UNITED STATES PATENT AND TRADEMARK OFFICE

APPLICATION NO.	FILING DATE	FIRST NAMED INVENTOR	ATTORNEY DOCKET NO.	CONFIRMATION NO.
09/413,348	10/06/1999	NORIHISA FUKUTOMI	Q56091	1912

Office Action Summary

DETAILED ACTION

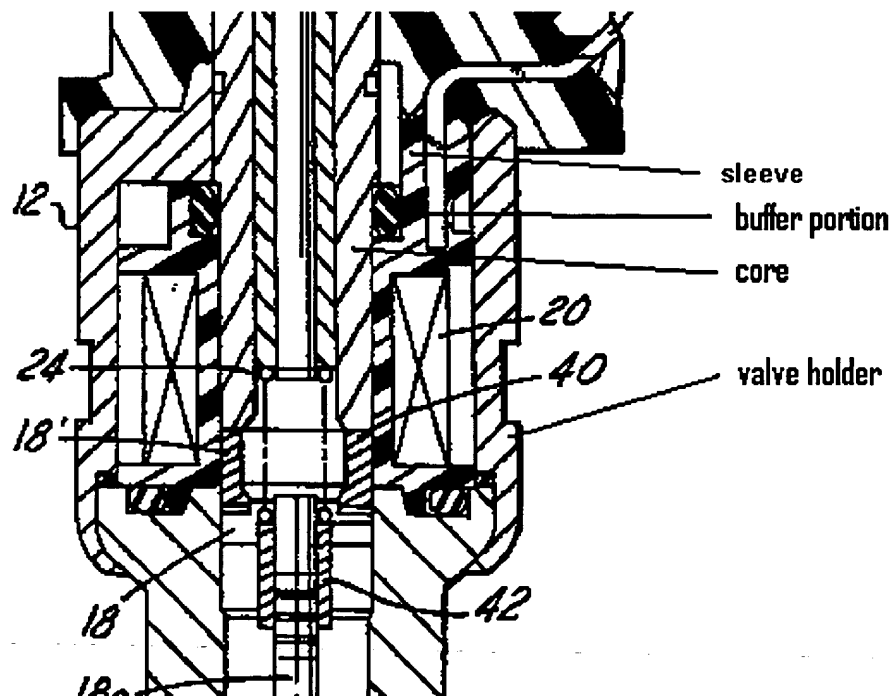
7. Claims 6-9 (as best understood) are rejected under 35 U.S.C. 102(b) as being anticipated by Asano (5,188,297).

Asano discloses a fuel injection valve comprising: a buffer portion/means for damping 39 being an elastic member (O-ring); a fuel passage 22f; an end face (down stream side of 32); a nozzle opening 27. O-ring 39 inherently functions as a buffer portion.
